Drainage Addendum

Site: Land to the North of Arundel Road, Fontwell, West Sussex BN18 OSF

Client: Harlequin Developments

Date: August 2026

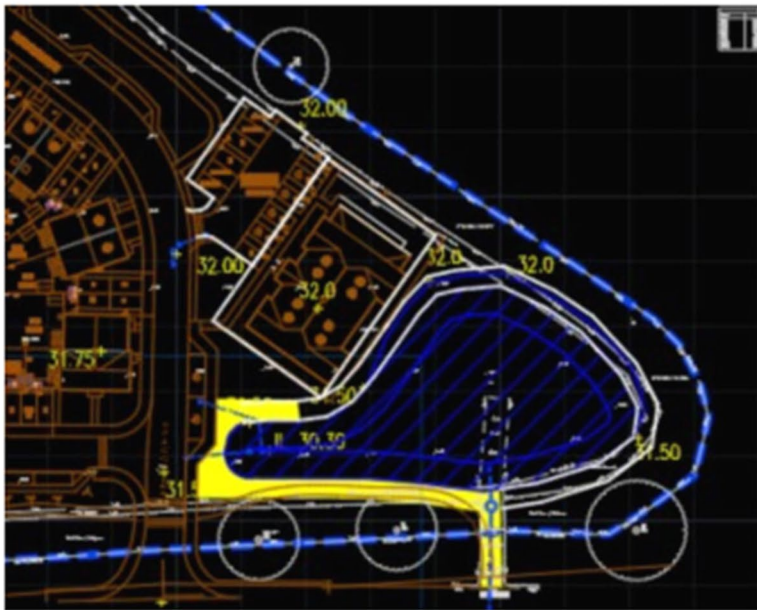
A minimum 3m easement for the attenuation basin is required, for maintenance access.

The easement shall go around the entire basin, rather than part of it. For the side near the building, it is unclear whether the basin can be safely maintained. As these issues could affect the layout and scale of the site, it would not be reasonable for the above to be covered via conditions at this stage

We have currently shown a 3m easement for maintenance for the inlet and outlet structures. Any other maintenance can be carried out from within the basin.

Notwithstanding the above we can tweak the layout to provide the 3m easement around the entire perimeter as below.

Title
DRAINAGE STRATEGY PLAN

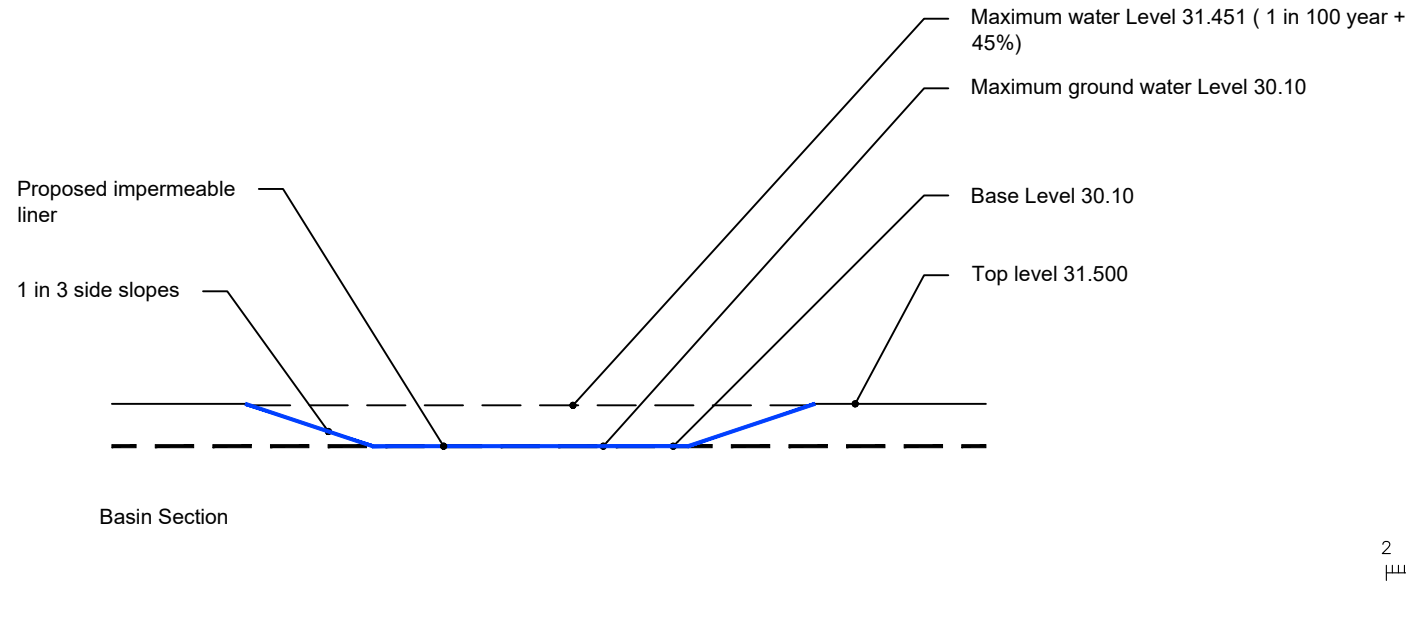
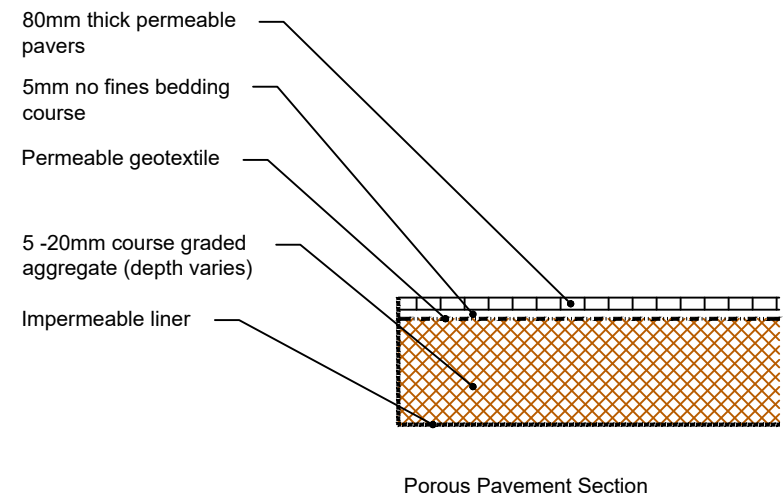
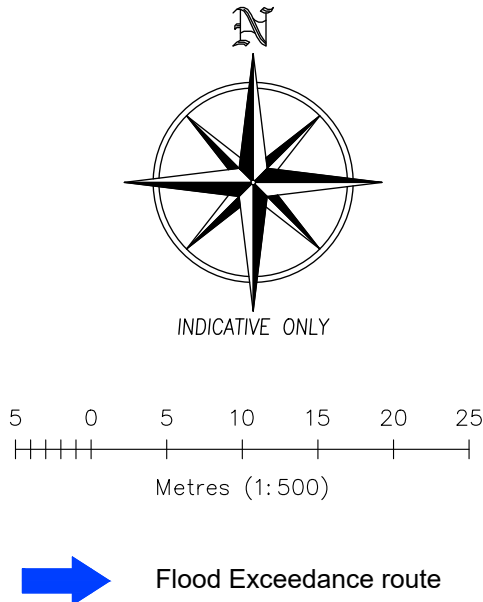
- 1.2.9 We would also note that the allowable discharge has been restricted to 5.4 l/s rather than the greenfield rate of 9.9l/s.
- "The liner does not appear to be included in the basin cross section."*

- "We require the updated drainage plan"*
- 1.2.11 Updated drainage plan has been provided in **Appendix B**.
- "As requested, we require the easement to go round the entirety of the basin. As these issues could affect the layout and scale of the site, it would not be reasonable for the above to be covered via conditions at this stage"*

The liner does not appear to be included in the basin cross section.

In addition, the permeable paving cross section is missing.

- 1.2.10 It has previously been stated the pond will be lined. A note has been added to drawing 33186-D-02 Rev P3. The section for the porous pavement has also been included on drawing.

- 1.2.12 A 3m easement has been provided around entire perimeter of the pond
